APOLLO 13 MISSION REVIEW

HEARING
BEFORE THE
COMMITTEE ON
AERONAUTICAL AND SPACE SCIENCES
UNITED STATES SENATE
NINETY-FIRST CONGRESS
SECOND SESSION

JUNE 30, 1970

FIGURE 1. Oxygen tank No. 2 internal components.

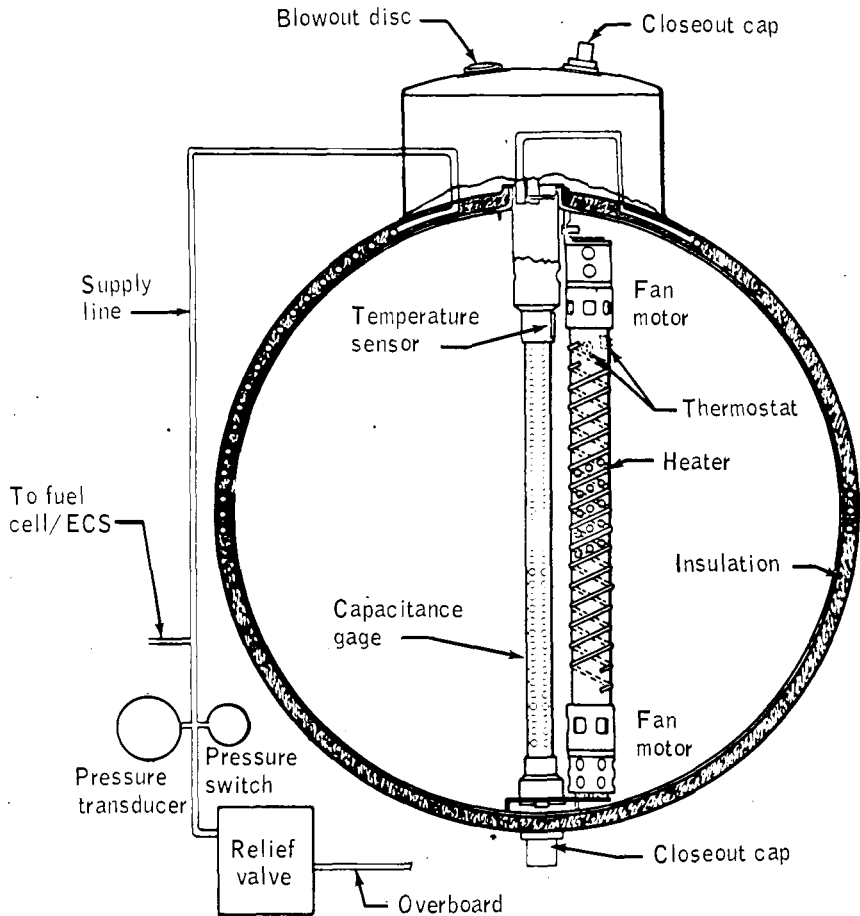
Slide 1 (see fig. 1) shows the simplified drawing of the oxygen storage tank in which the accident occurred. I will just say a brief word about this slide to orient you to the nature of the problem that was encountered.

FIGURE 2. Oxygen tank wiring and lines.

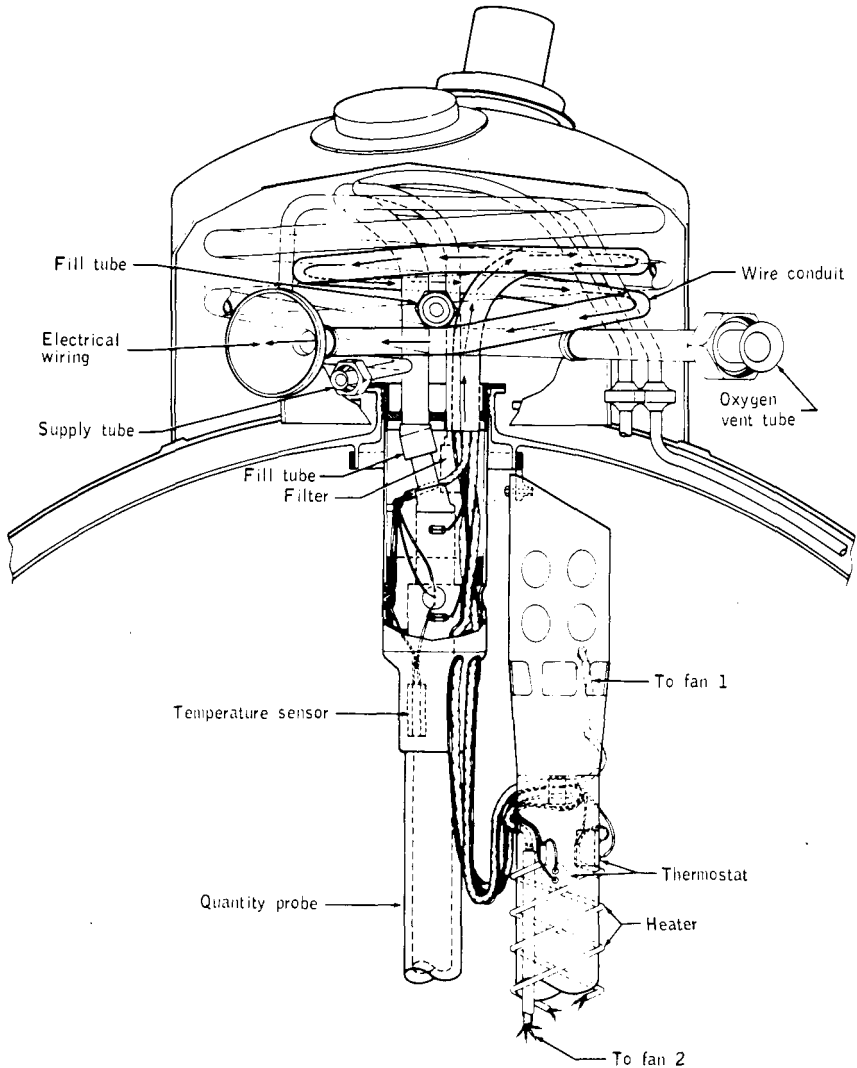
Now, the second slide (see figure 2) shows this in a little more detail. As you can see at the top of the heater-fan assembly the word "thermostat" is shown with two arrows. These arrows point to the two thermostatic switches which failed. In addition, there is a fill tube assembly shown right here at the top of the quantity probe which was loose in a manner which I will describe in just a moment and this led to a special detanking procedure which failed those switches and ultimately damaged the wiring.

Now, in addition to these thermostatic switches which subsequently failed, it is probable that the tank contained a loosely fitting fill tube assembly which I just pointed out. This assembly was probably displaced during subsequent handling after shipment and this handling included an incident at the prime contractor's plant in which the tank was jarred.

FIGURE 3

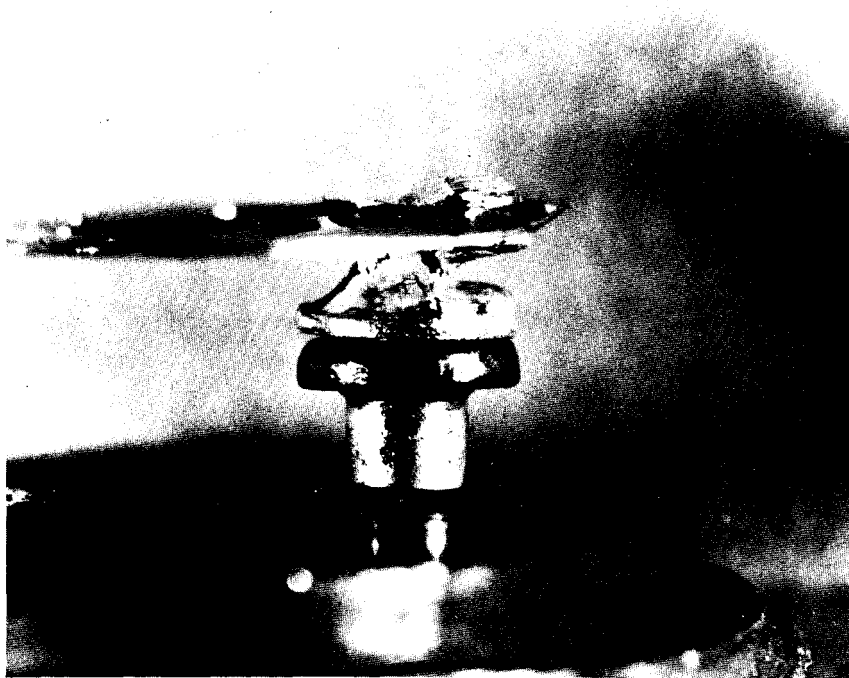
which was failed with this current during tests at the Manned Spacecraft Center. The drawing is in the report and in the statement that I submitted today—the photograph is in there.

FIGURE 13

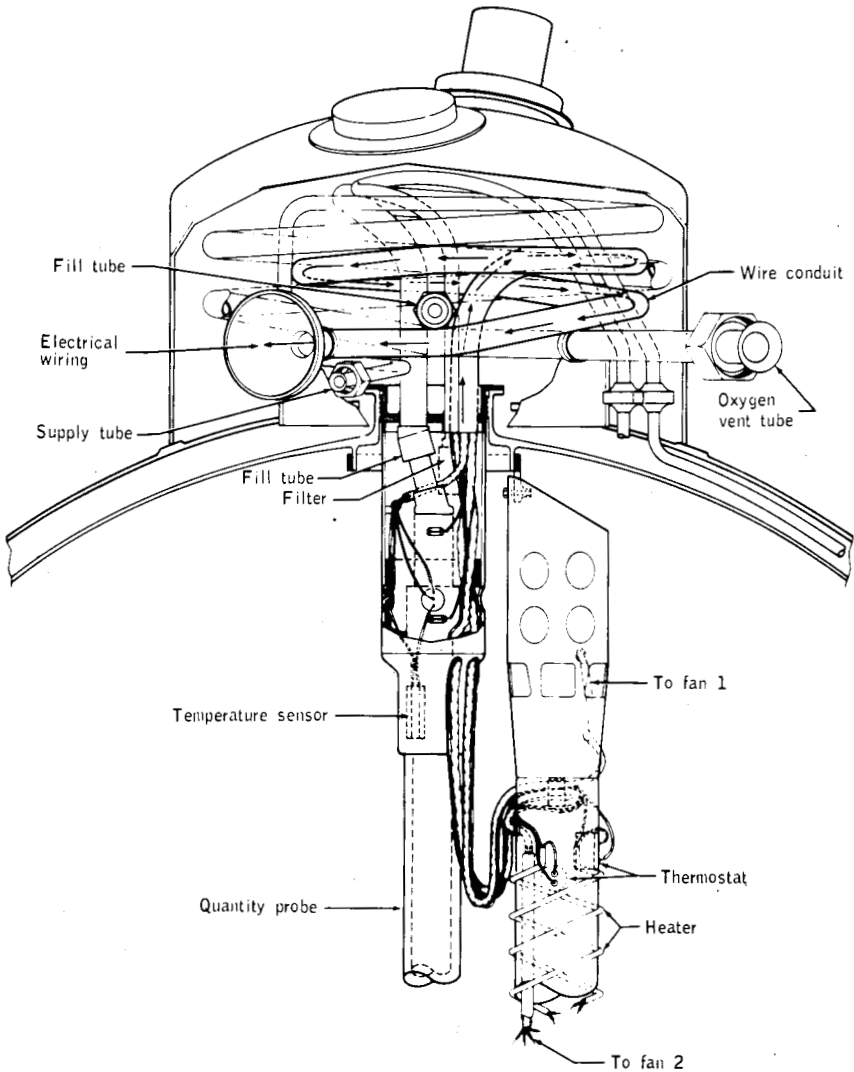
As shown in figure 13, each heater coil is protected with a thermostatic switch, mounted on the heater tube, which is intended to open the heater circuit when it senses a temperature of 80°F. As I will point out later in tracing the Board's conclusions as to the cause of the accident, when the heaters were powered from a 65 volt DC supply at KSC during an improvised detanking procedure, these thermostatic switches, because they were rated at only 30 V DC, could not prevent an overheating condition of the heaters and the associated wiring. Tests conducted for the Board indicate that the heater tube assembly was probably heated to a temperature of as much as 1000°F during this detanking procedure.

FIGURE 23

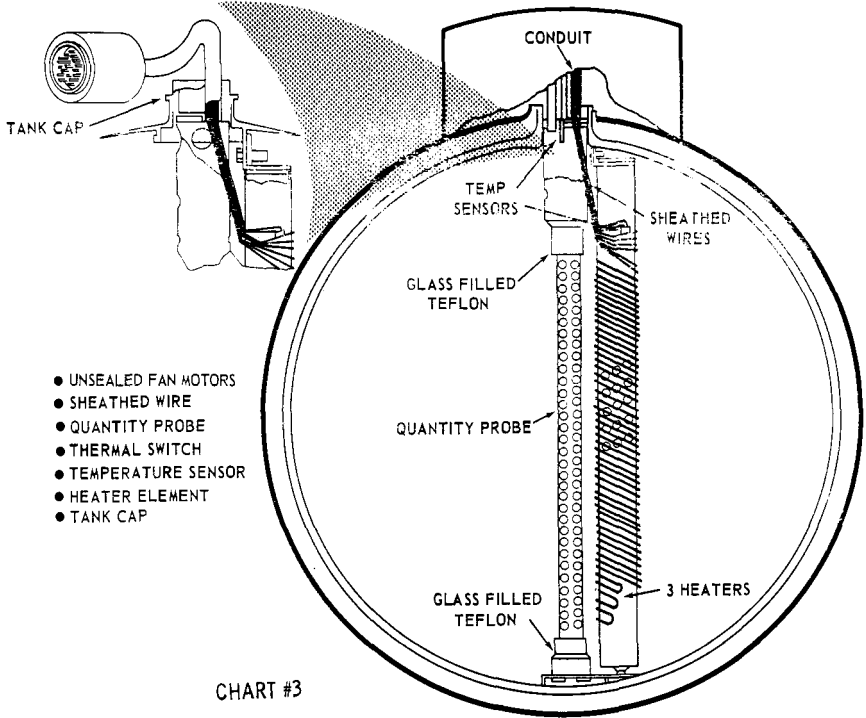
Senator GOLDWATER. Dr. Petrone, I notice on your next chart you call for unsealed fan motors, yet you do not show them.

On chart 3 (fig. 23), I show a basic drawing of what the tank would look like schematically with our modifications. The items on the left are notes which would say, one, we are going to remove the unsealed fan motors. We will use sheathed wires. The quantity probe, which we have to retain will be changed from aluminum to stainless steel. The thermal switches will have been removed. The temperature sensor, the second one will have been added. As I mentioned, we will add a third heater element for redundancy. The tank cap will be modified to simplify the basic installation of the heater probe assembly.
